**Reference: Peer Review Report
35-37 Interlaken Road, Stockbridge**

Our office appreciates the opportunity to provide this peer review for the project referenced above, and provide recommendations and commentary to the Town of Stockbridge Select Board. We have conducted this review based on the following documents supplied to our office by Harrington Heep LLP:

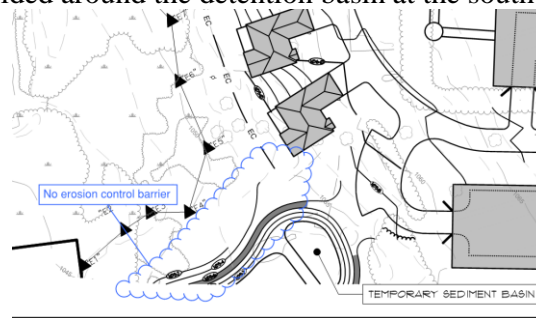
The Applicant appears to be contradicting the first paragraph of the section on Standard 8 with the final section of Standard 8 where they suggest the SWPPP follows the requirements of this stormwater standard and complies with the NPDES CGP. We do not have a copy of the SWPPP, and one should be provided to confirm it complies as the Applicant has stated.

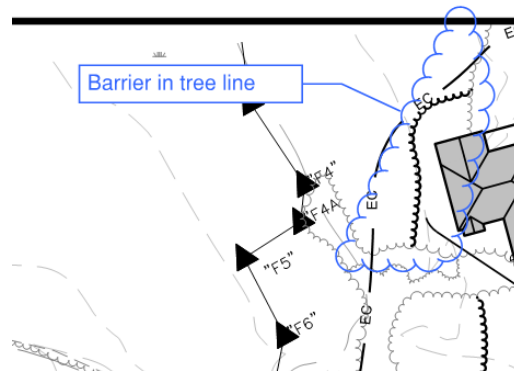
- No erosion control barrier is provided to the east of the Detention Basin.
- Within the field adjacent to Interlaken Road, where the Applicant is proposing to construct a grass on gravel parking lot, no silt fence is proposed on the downstream side of the grass on gravel, which could lead to sediments migrating towards Interlaken Road.
- The erosion control barrier in a couple locations at the northwestern corner of the site is called to be installed inside the tree line. The Applicant should clarify why the silt fence would be installed in the tree line. One example screenshot is provided below:

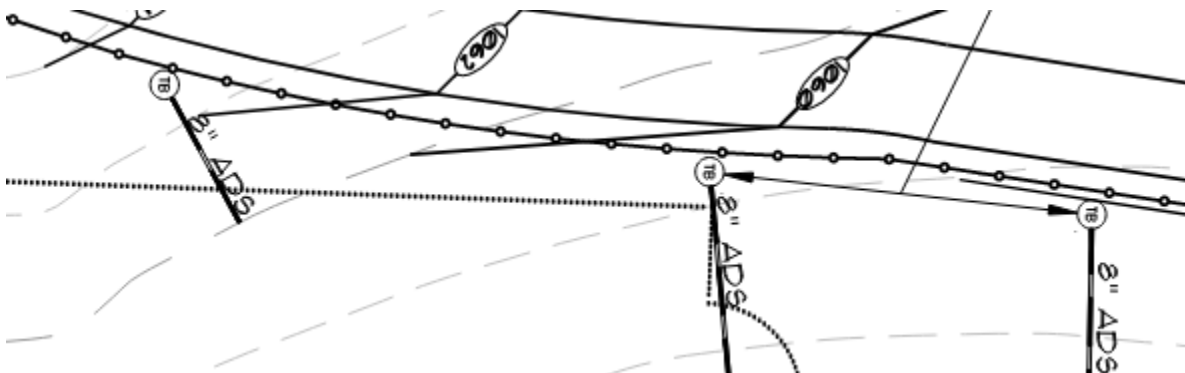
SW Comment 41 - Along the entrance roadway there is 500' of proposed road with no drainage structures. This a long path for water to travel without some sort of treatment structure as water will accumulate the whole stretch of the road. It is unclear how this water is captured before Interlaken Road.

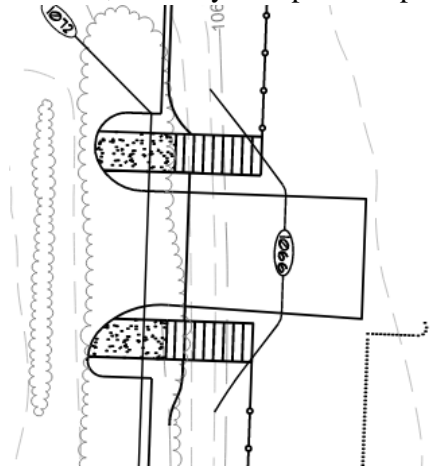
SW Comment 42 - The plans show multiple tree box filters that don't appear to collect any water. Further detail should be provided to show how water is collected in the structures.

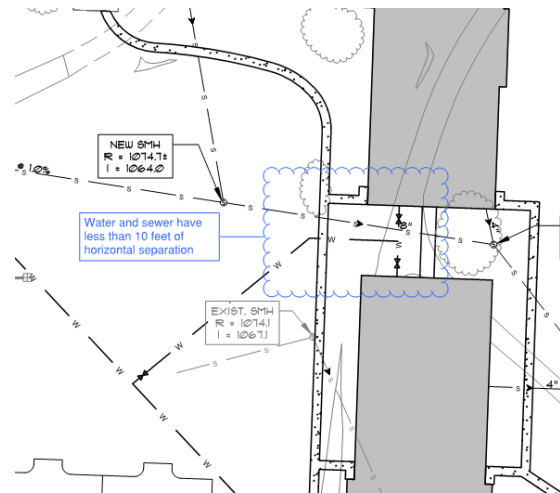
SW Comment 48 - The detail sheets show a parking lot detail with a 6" high curb, but do not indicate where the curbing would be installed on the Site Plan. The detail also shows the curb on top of the binder, but below the finished grade. The Applicant should clearly depict the reveal of the curb and where it is proposed to be installed.

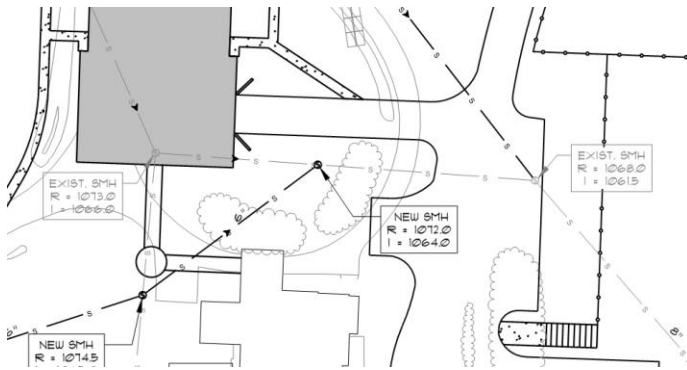
UT Comment 6 - It appears that the water service may abandon the existing water service running along the western portion of the site adjacent to the wetland. We also noted numerous locations where existing utility poles were located within the proposed driveway. The Applicant should provide a plan demonstrating what utility services will be abandoned, removed, re-located, re-used, etc. as clarity for the board.

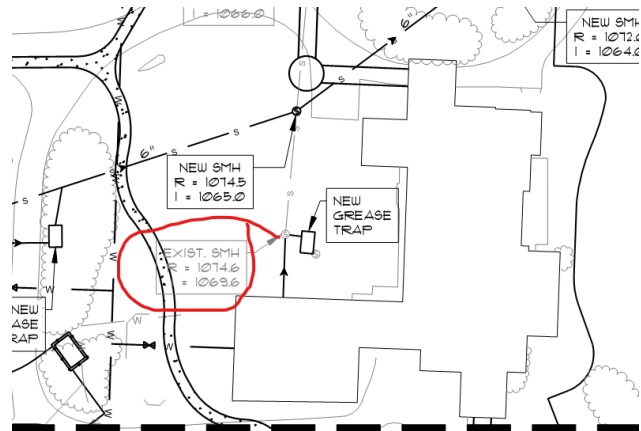
UT Comment 12 - There are a few locations where there will be a utility conflict. As a few examples, on the eastern side of Building B, a 4" and 8" sewer line intersects a proposed groundwater infiltrator for the rooftops. As another example, on the western side of Building B, a water line goes through a catch basin. The plans should remove these types of conflicts.

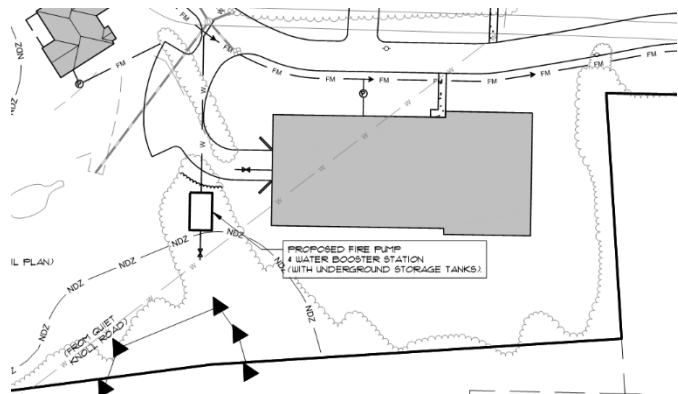
UT Comment 14 - A fire pump and water booster station are proposed within the tree line on the western side of Building H. It is unclear how the tree line will be maintained with the proposed fire pump and booster station. Additionally, it appears that the plan is only showing the proposed pump house, however the detail provided on Sheet 6 indicates an external 11,000 gallon, 8' diameter pipe to be installed on the outside of the pump house. The location of both 11,000-gallon pipes should be shown on the plan view. Additionally, the prefabricated dead men appear to be within the zone of influence of the footing of the pump house. The Applicant should confirm whether it is constructable to have the dead men in close proximity and below the footing of the pump house.

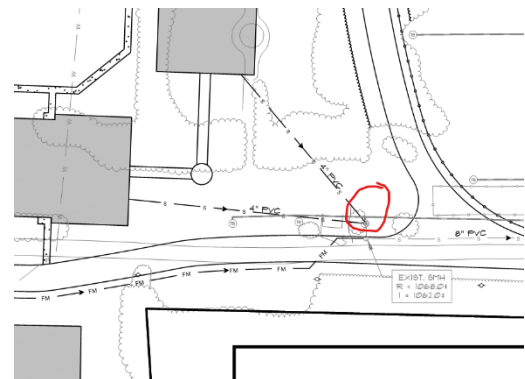
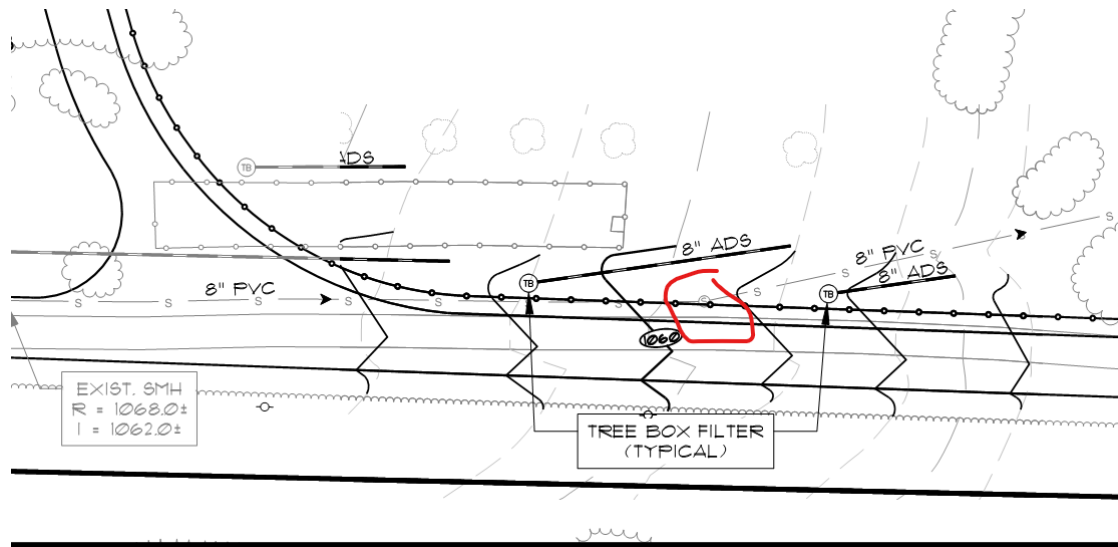
UT Comment 16 - A tree well is proposed on the location of an existing sewer manhole to the east of Building F.
